## SERVICE BULLETIN

**Title:** 23XL Slide Valve Support  
**Models Affected:** 23XL with D Series  
Compressors

**Number:** C9804  
**Date:** 1/30/98  
**Supersedes:** New

**Slide Valve Relief Shelf**

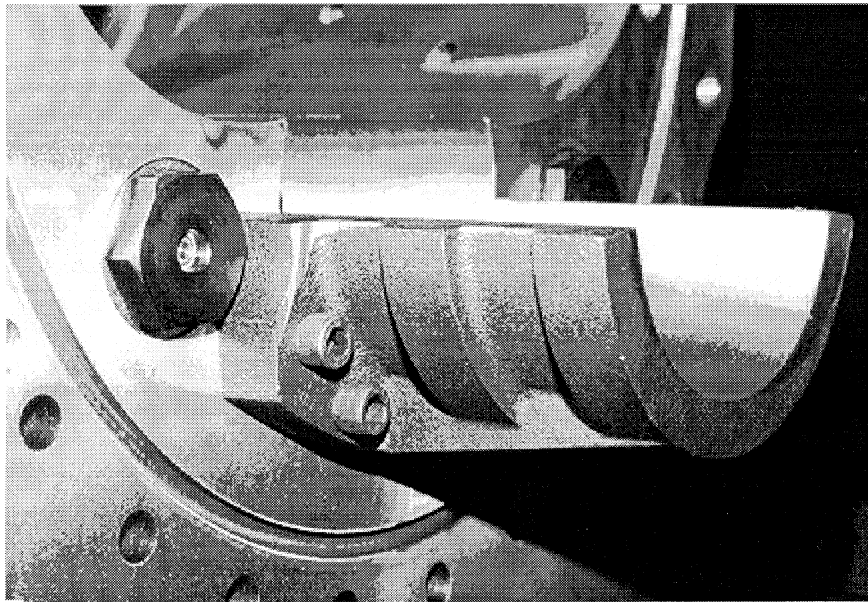
This bulletin is provide to advise the field of a product improvement, the implementation of the slide valve relief shelf.

The slide valve relief shelf will provide support at low load.

23XL frame 4 chillers having D40, D41, D60 and D61 compressors. Starting with chillers built after week ending 4197 having D series compressor with serial number 3897V02382 and higher.

The relief shelf is not retrofitable to existing D series compressors. The relief shelf must not be removed from rotor casing for alignment reasons.

For D series compressor without relief shelf it is recommended that a slide valve clamp be installed during overhaul of the slide valve assembly. Refer to Bulletin C9803 Slide Valve Rework Procedure.
